Proposed work to TPO trees: Tree Warden's comments

Ref. No: DC/20/4516/TPO

[Lime T2 - to remove two lowest branches, one over sailing club, one on opposite side to balance tree, smaller branches over sailing club, reduce by half, crown lift to first major fork, all to reduce overshading. Oak in W2 - remove two lowest branches and major deadwood, to reduce risk to path and hut users below. - Waldringfield Sailing Club Cliff Road Waldringfield Suffolk IP12 4QL](#)

My photo (View 3) from the top of the steps with the foliage of the lower branches helping to screen the Sailing Club from view. Limbs A and C are dead . Limb B is healthy apart from a small amount of dead wood near the end of the branch.

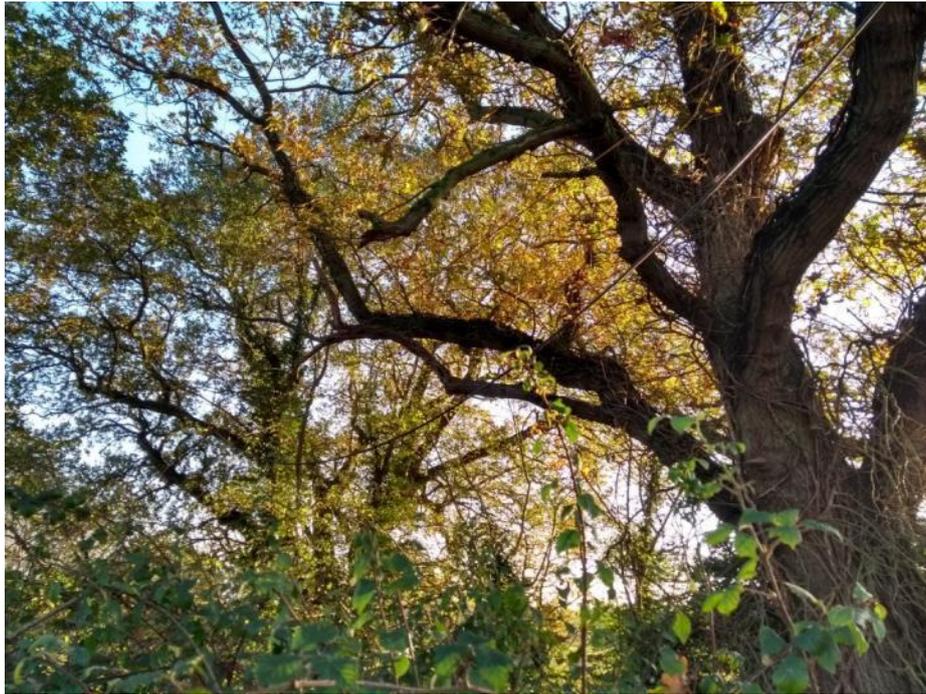
This old veteran pollard may be one of the 300 year old oaks mentioned in the SCDC description above. It grows at the top of the wooden steps which lead down to the beach, up and down which many families have climbed over the years.

The tree has some dead wood which might be removed . The branches which are healthy with foliage on them frame the view coming down the steps. The hut below with red roof is some distance from the farthest extremity of the branches and the other shed fitted into the bank more recently is also beyond the canopy. I would propose that only dead wood is removed . However it should be noted that older oak trees usually have some dead wood on them which is beneficial to wildlife such as woodpeckers and insects. In this case the larger dead branches have been shortened by being chopped off at right angles in the past which poor practice may have led to their subsequent death by allowing in pathogens .

View 4 of the oak tree from small gate half way up the steps.

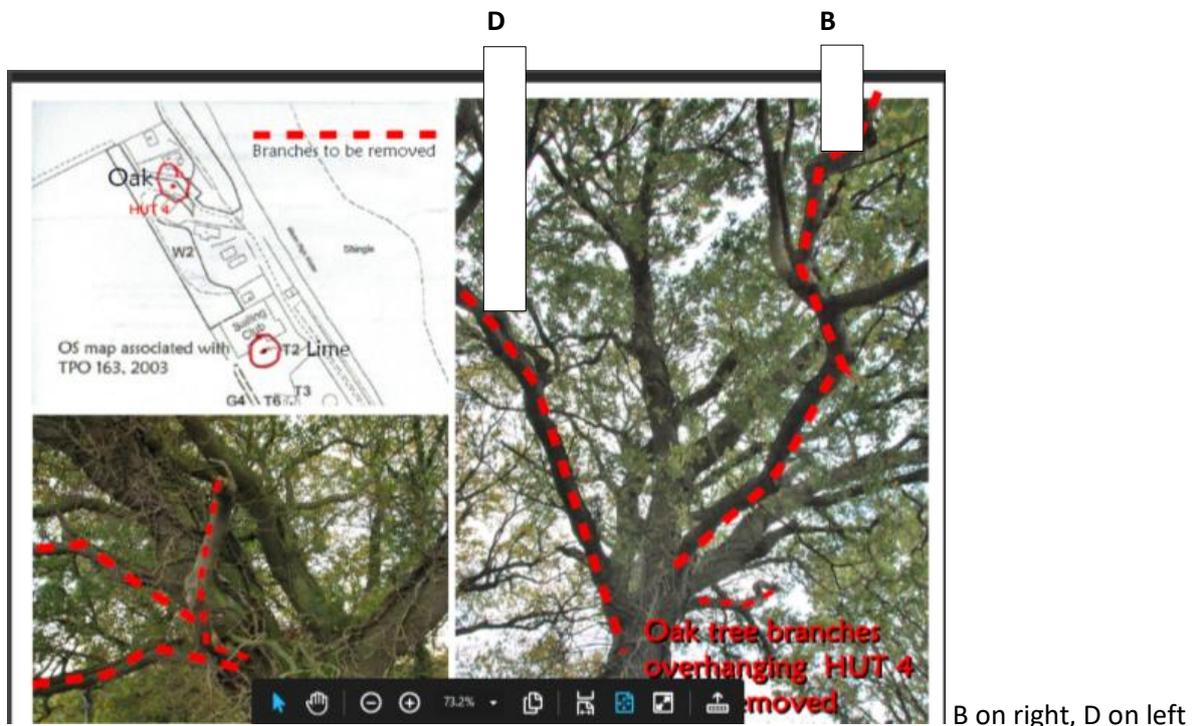
The other limb proposed for removal, limb D is largely healthy but carries some dead wood on one of its side branches.

B on right, D on left

The applicants's submission. It is not altogether clear which branches are referred to. However having viewed the tree several times I think limb D is one which has a side branch off it with some minor dead wood at the end of it . I would submit that removal of dead wood is sufficient work on this venerable old tree.

The small amount of dead wood does not warrant removing largely healthy branches which frame the view with foliage, as one descends the steps.
